NL-11-1057

Joseph M. Farley Nuclear Plant Units 1 and 2  
License Amendment Request for Technical Specification Table 3.3.1-1

**Basis for Proposed Change**

Figure A-1

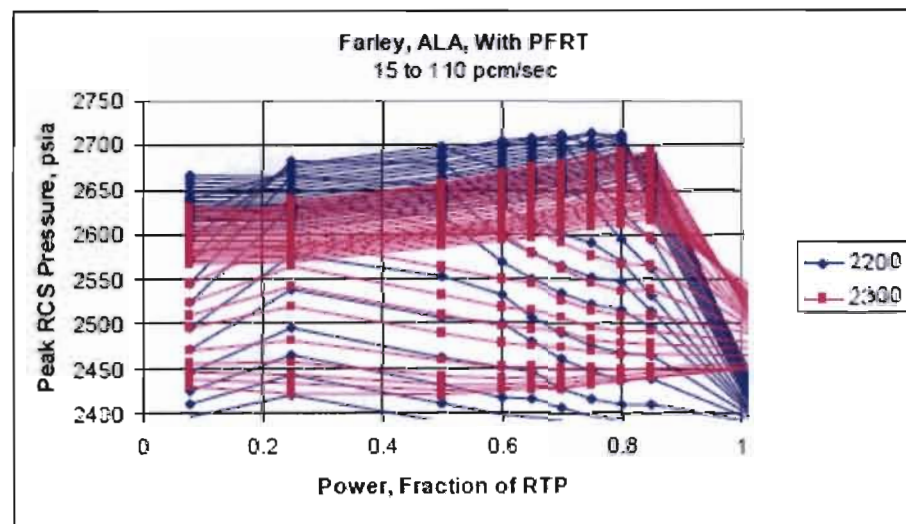
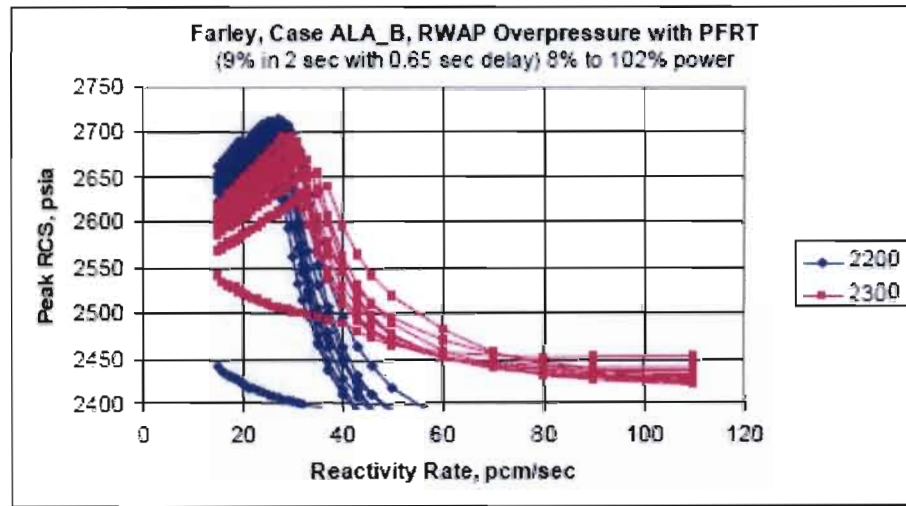
These analyses were based on the key parameters for the Farley units listed on Table A-1. The Farley analyses for a PFRT at 9% of RTP with 0.65 second delay involved 680 individual LOFTRAN computer runs at various initial conditions and reactivity insertion rates. The results are plotted on the attached Figure A-1. Two plots are provided: peak RCS pressure versus reactivity insertion rate; and peak RCS pressure versus initial power level. Both plots are based on the 340 transient calculations starting from a pressurizer pressure of 2200 psia and the 340 transient calculations starting from a pressurizer pressure of 2300 psia. These analyses calculated an acceptable result (i.e., RCS peak pressure not in excess of 2750 psia) with a PFRT at 9% of RTP, a lag time constant of 2.0 seconds, and a trip delay time of 0.65 second.
